**Planned Unit Development -
Lots 1 & 16 Harrison Hills—Streck, Inc.**

RECOMMENDATION REPORT

CASE NUMBER: PPUD-19-0002

RE: Planned Unit Development – Initial Review
Streck, Inc. – Harrison Hills

PLANNED UNIT DEVELOPMENT
PHASING PLAN EXHIBIT

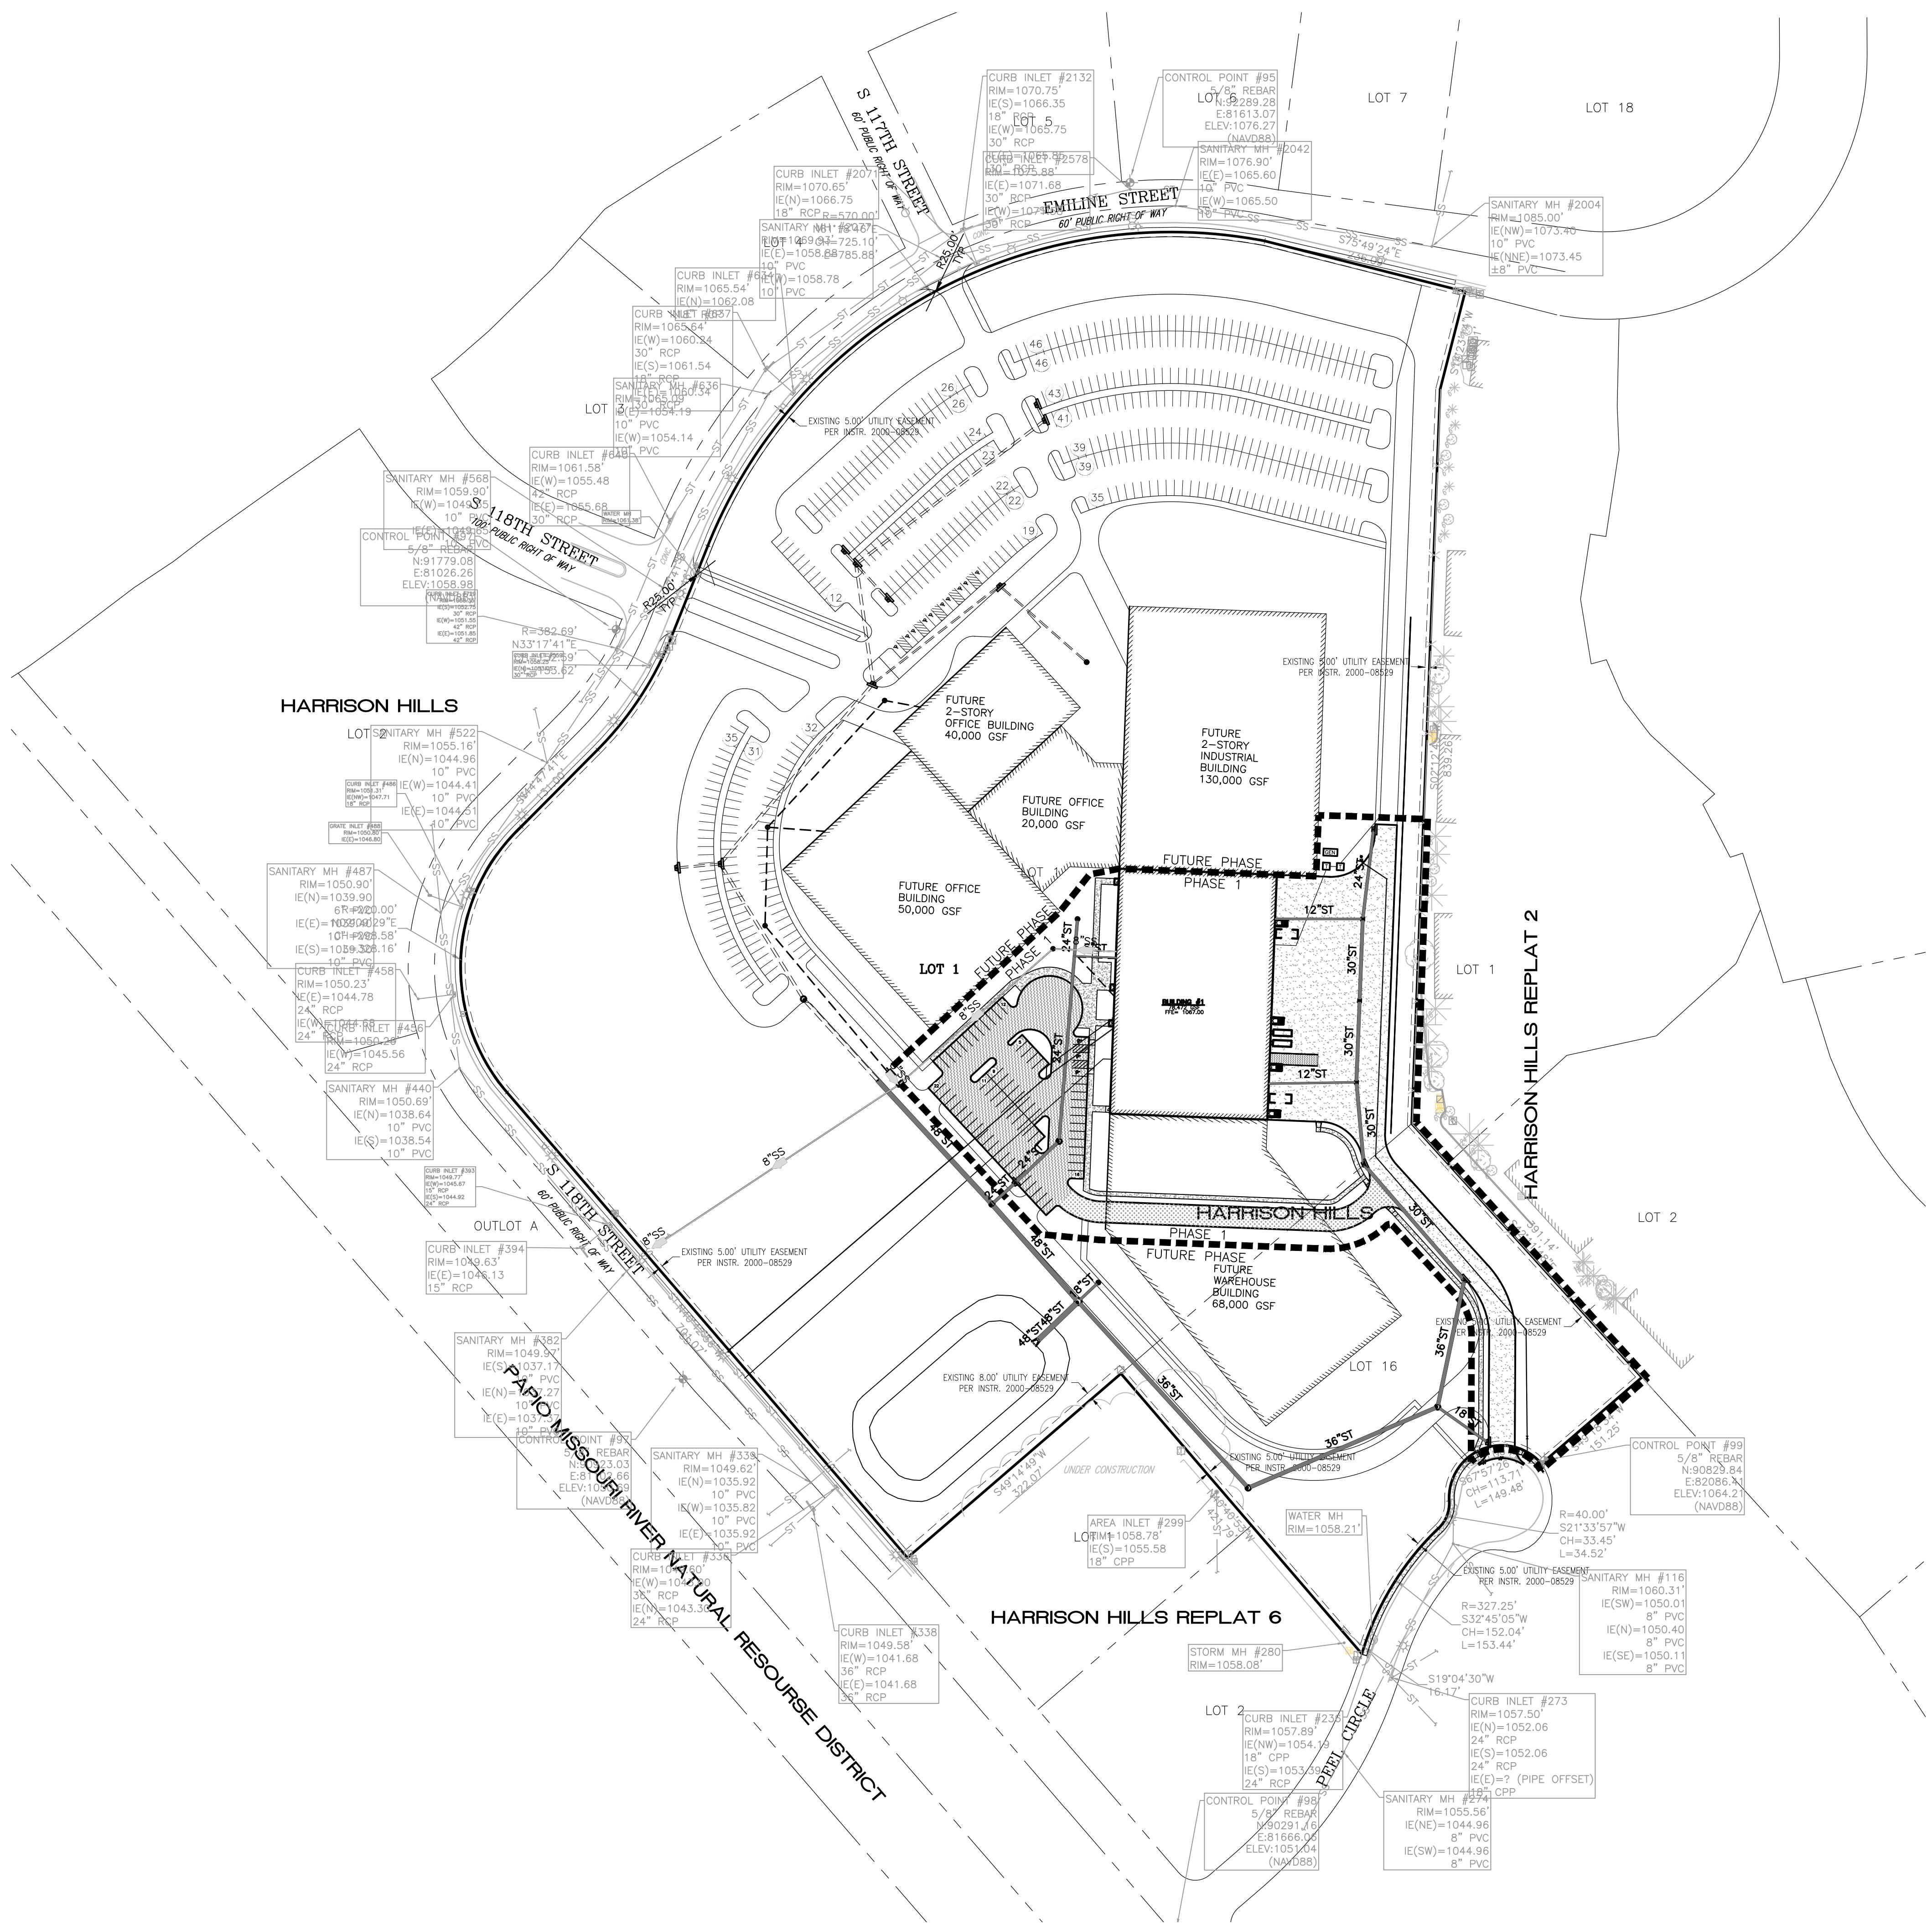
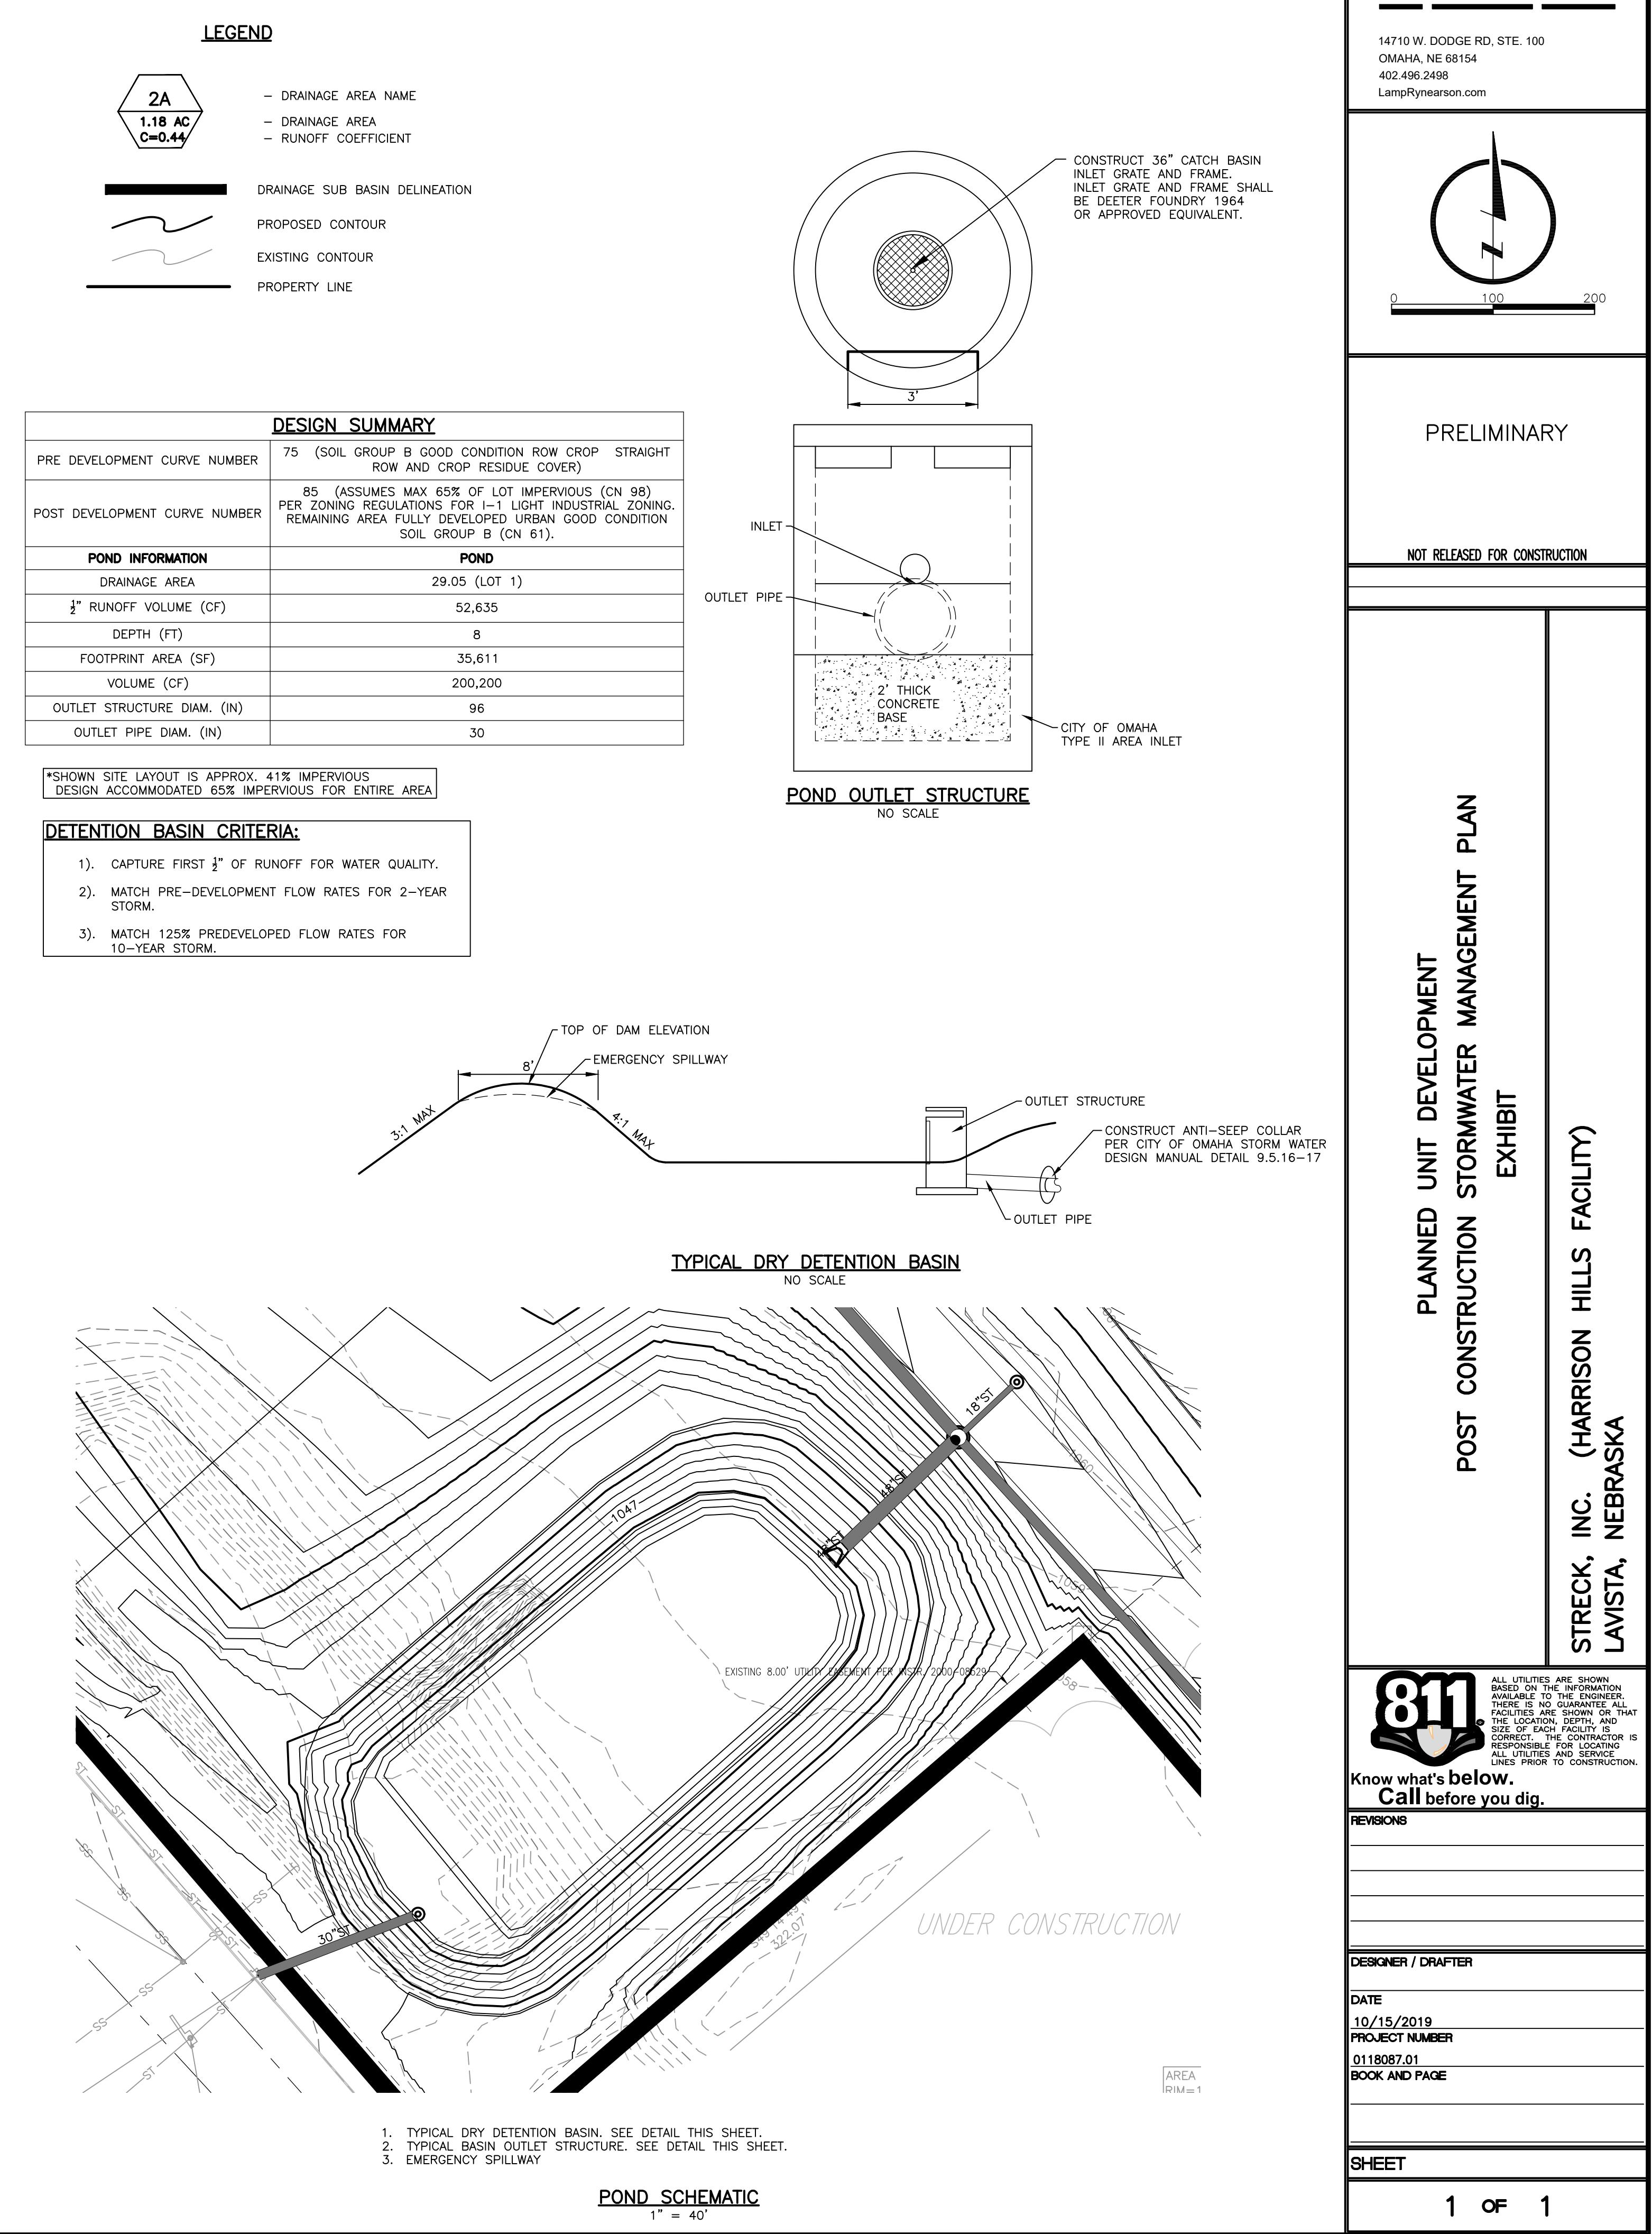
6. Comment Response #11 – Sanitary sewer connection fees and stormwater management fees were noted per the PUD Development Fee Table per the PUD Phasing Plan Exhibit, however the fee rates were not consistent with the current Master Fee Ordinance. Current Watershed Fees are \$4,963/acre (as of 7/1/19) and Sewer Connection Fees are \$7,407/platted acre (as of 1/1/2019).

Response: The PUD Development Fee Table has been updated per the 2019 fees listed above.
